Land to the East of Longwater Road, Finchampstead

Addendum Arboricultural Note

edp4070_r015a

Appendix EDP 1
Site Layout
(CATE230603, DWG No. SL01, Rev. A6, 26.03.24)

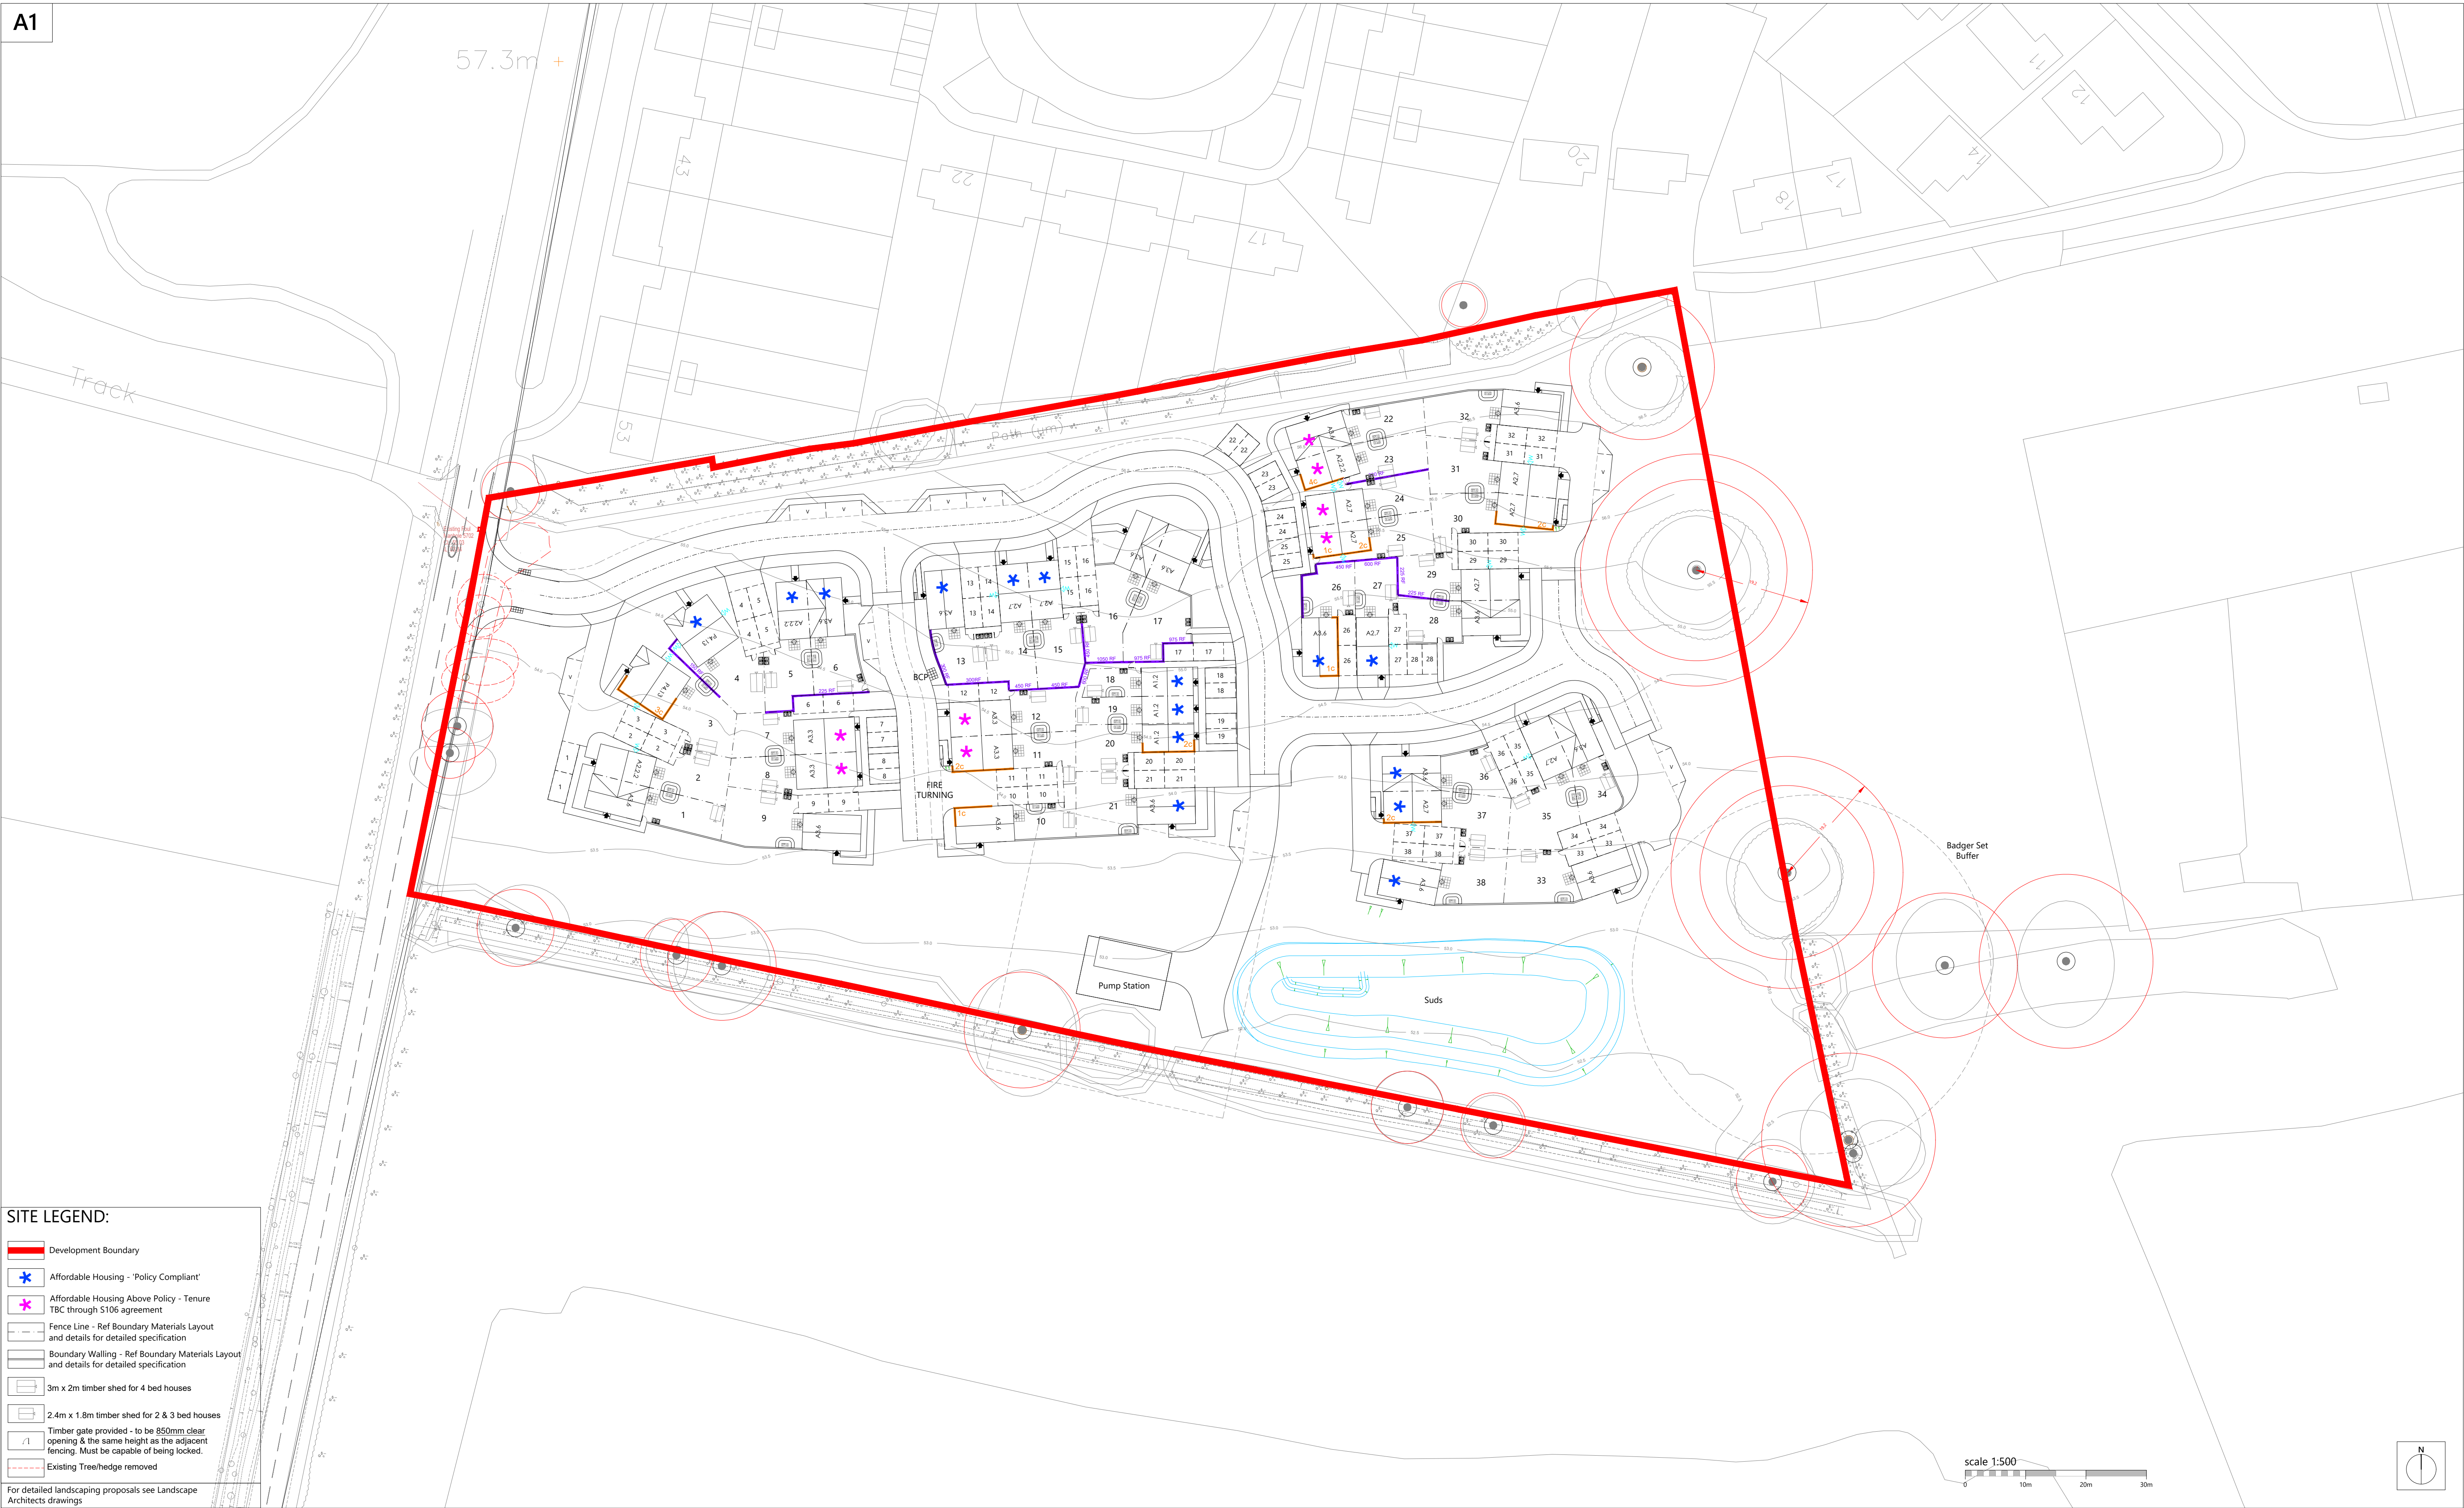
- 1.4 To address comments raised by consultees, the Site Layout for the Planning Application has been further revised with an amended Site Layout as illustrated in **Appendix EDP 1** and the Levels and Drainage strategy, see **Appendix EDP 2**, resulting in the reduction in number of dwellings by two and the repositioning of the units further away from the southern boundary of the site. As such, this AAN reviews the implications of the most recent revised details, clarifies how these revisions to the layout affect the conclusions detailed within the existing Arboricultural Impact Assessment (AIA) (report reference: edp4070_r013), and makes any additional recommendations, where appropriate.

Rev	Description	Date	Au	Ch
A	Issued for Planning	31.05.24	MK	
A1	Single Driveways increased to 3.1m wide, Visitor space added adjacent plot 33-36. Parking for plots 26-29 reallocated.	19.08.24	MK	
A2	Amended to suit CMP-02	16.10.24	MK	
A3	Amended to suit Client comments	21.10.24	MK	
A4	Amended to suit Engineer's comments	23.10.24	MK	
A5	Amended to allow 19.2m RPA.	01.11.24	RA/MK	
A6	Affordable annotations added, engineer's info added.	19.11.24	MK

Plan EDP 1: Tree Protection Plan
(edp4070_d034c 18 November 2024 DJo/GSn)

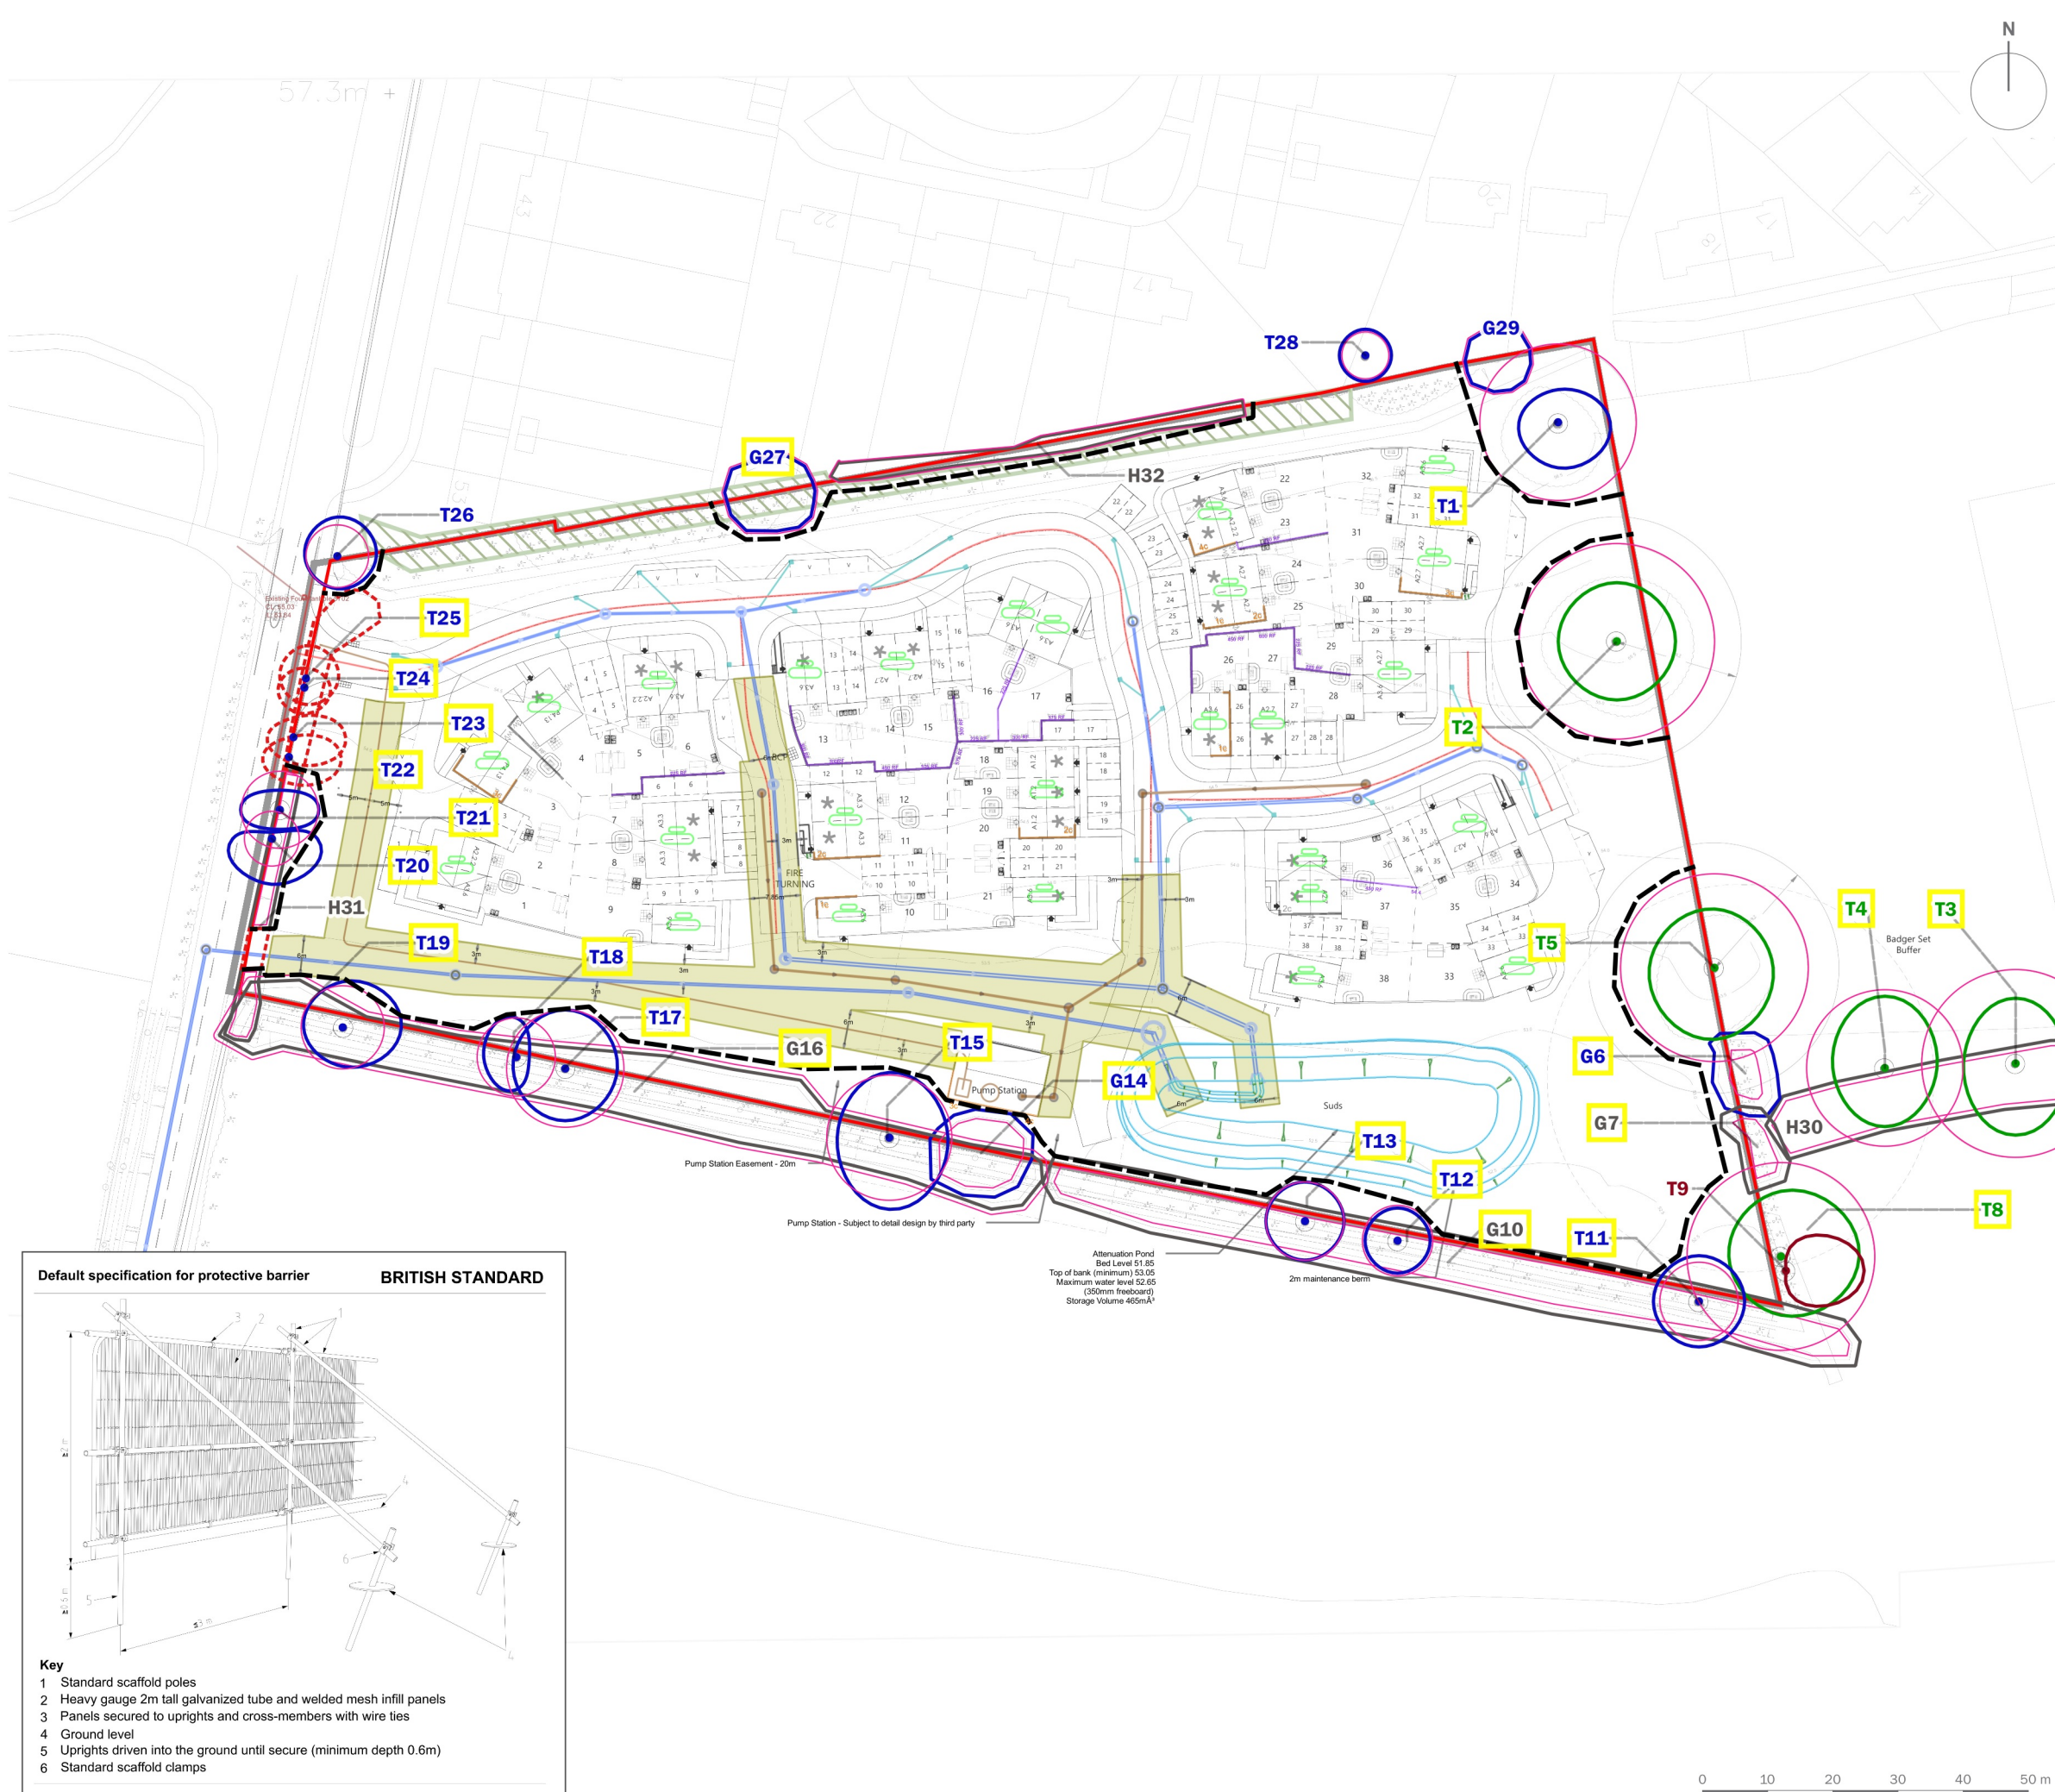
- 1.5 This AAN has been produced to assess the new proposals as illustrated within **Appendices EDP 1** and **2**, which are overlaid onto the Tree Constraints Plan. The resulting drawing is a revised Tree Protection Plan (**Plan EDP 1**), which will ensure the long-term retention of trees in relation to proposed development.

- 2.1 In their response to the original submission, the Landscape and Tree Officer highlighted the amenity, ecological and arboricultural value of **T2** and suggested it is a veteran tree. However, a Recognition of Ancient, Veteran and Notable Trees (RAVEN 2) assessment was undertaken during the original survey, and it did not qualify as a veteran, however, **T2** does have notable features. To allow **T2** to continue to age and veteranize, an extended area free from construction has been allowed for within the proposal. The suggested radius of 19.2m of no construction by the Tree Officer will allow this notable tree greater protection.

- 2.2 To facilitate this additional area, the units and surrounding hardstanding have been repositioned so that there is now no development within the 15m root protection area (RPA) or the extended area beyond the RPA totalling 19.2m of this high quality Category A oak.

c	Updated site layout	18/11/2024	PDr
b	Updated site layout and client/project name	10/06/2024	VMS
-	Original	08/04/2024	DJo
rev	description	date	by
